Mobile Intel[®] Pentium[®] II Processor Specification Update

Release Date: October 2006

Order Number: 243887-056

The Mobile Pentium[®] II processor may contain design defects or errors known as errata which may cause the product to deviate from published specifications. Current characterized errata are documented in this Specification Update.

Figure 2. Workaround Flowchart: SMBALERT#-Driven System

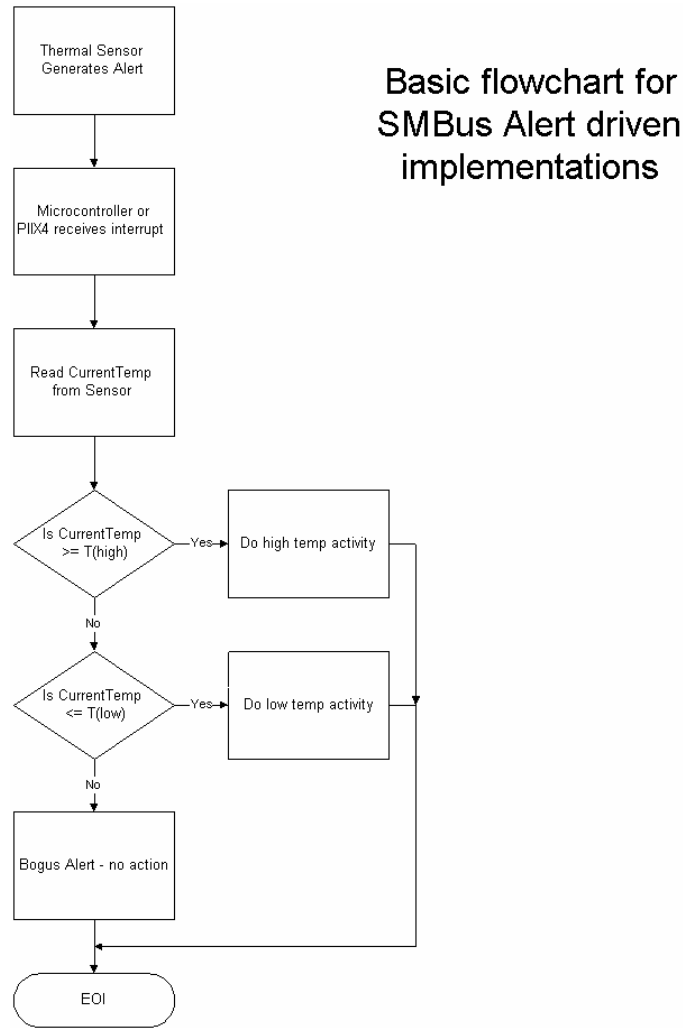
Under the conditions described below, the thermal sensor incorrectly generates the SMBALERT# interrupt. All of the following conditions must be met to trigger a false interrupt:

1. Before servicing an interrupt from the thermal sensor, read and compare the processor thermal reading with the threshold limits (T_{HIGH} or T_{LOW}). Figures 2 and 3 provide basic flowcharts for the implementation of this workaround in an interrupt driven system.
2. If the firmware implemented polls the Status Register only, then before taking any action, re-read the temperature register and do a comparison with the alarm threshold limits (T_{HIGH} or T_{LOW}) to determine if the value is actually still within the temperature window.

Figure 3. Workaround Flowchart: SMI#-Driven System

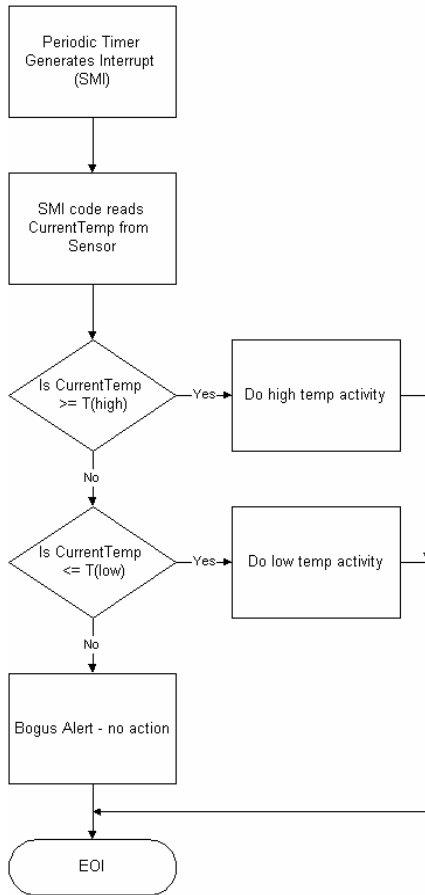
- Use a temperature polling scheme to monitor the processor temperature.

Figure 1. TAP Gageable Thread Clarification

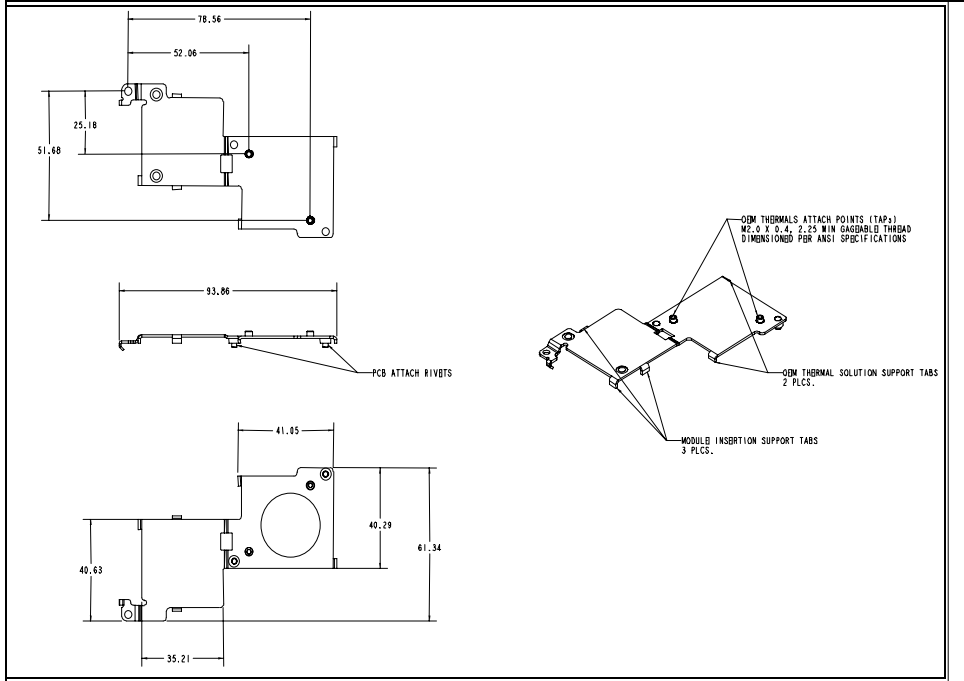
In the *Intel® Pentium® II Processor Mobile Module : Mobile Module Connector 1 (MMC-1)* and the *Intel® Pentium® II Processor Mobile Module : Mobile Module Connector 2 (MMC-2)* datasheets (Order Numbers 243667 and 243668, respectively), the thermal attach point (TAP) gageable thread specification was not clearly identified in Figure 14, of Section 5.2. The following is the TAP clarification:

OEM Thermal Attach Points (TAPs) M2.0 x 0.4, 2.25 min gageable thread dimensioned per ANSI specification.

See Figure 1 below for more information.
